Gary C Matteson Comments on Draft SB100 Joint Agency Report

Re: Comments on the California Energy Commission Docket No.19-SB-100: Senate Bill 100 Draft Report Workshop

Study: No Combustion Scenario

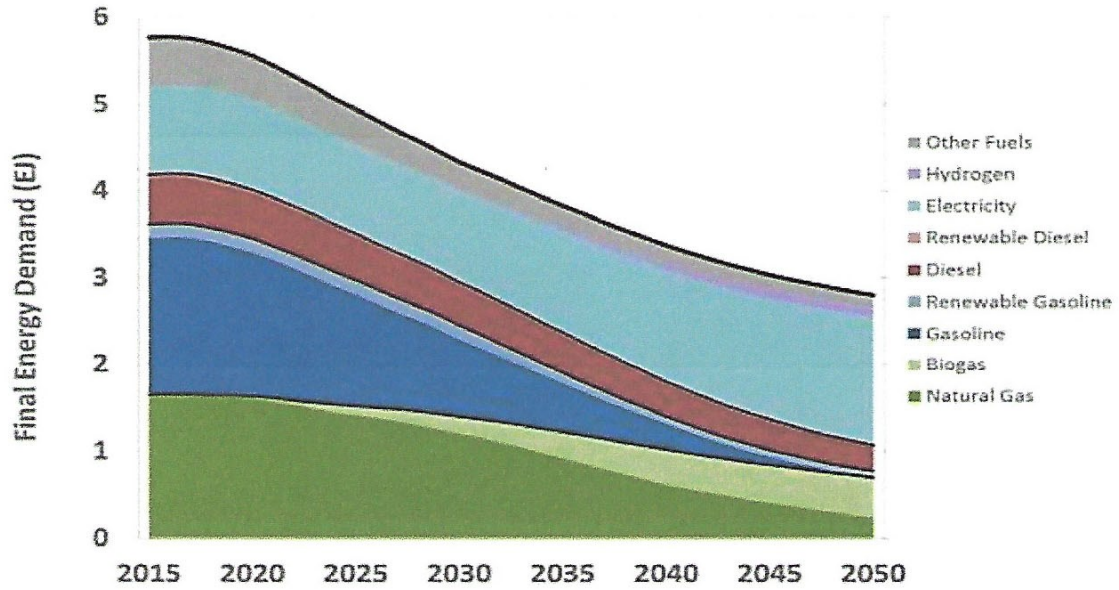
Here is a CEC forecast for what the annual generation for only electricity in California could look like in 2045 given “no combustion” energy generation. Source: CEC Docket # 19-2B-100, SB 100 Joint Agency Report TN# 234549, Author Liz Gill, 09/02/2020 pp 34. This forecast relies on electrification with Natural Gas, Biomass, combined heat and power, going to zero by 2045. Nuclear is held to present levels. Only Hydrogen for fuel cells is shown. Surprisingly, off shore wind is shown to be making a contribution in and after 2040. Energy Storage losses are shown to be negative. This forecast is counting on significant growth in solar, and wind. Big hydro remains as is. The total annual generation goes from about 280,000 GWh in 2017 to 500,000 GWh in 2045. 500,000 GWh is equal to 1.71 Quads.

Neither of the above graphs show the total energy sources required for 2045. My earlier work determined the level of energy sources to support California’s expanded population in 2040 to be 10.49 Quads and in 2050 to be 11.54 Quads. Source: G.C. Matteson, 2012, Energy Planning for Regional and National Needs, A Case Study- The California Forecast Chapter 5. The new economics Global Cases in Energy, Environment, and Climate Change. Springer ISBN 101461449715. pp 93. The forecast for USA by the US Energy Information Administration is 108 Quads for 2050. Source: US Energy Information Administration #AEO 2019, www.eia.gov/aeo pp 28. Given that California is about 10% of the nation’s energy consumption, this shows my 2040 and 2050 projections to be in the ball park.
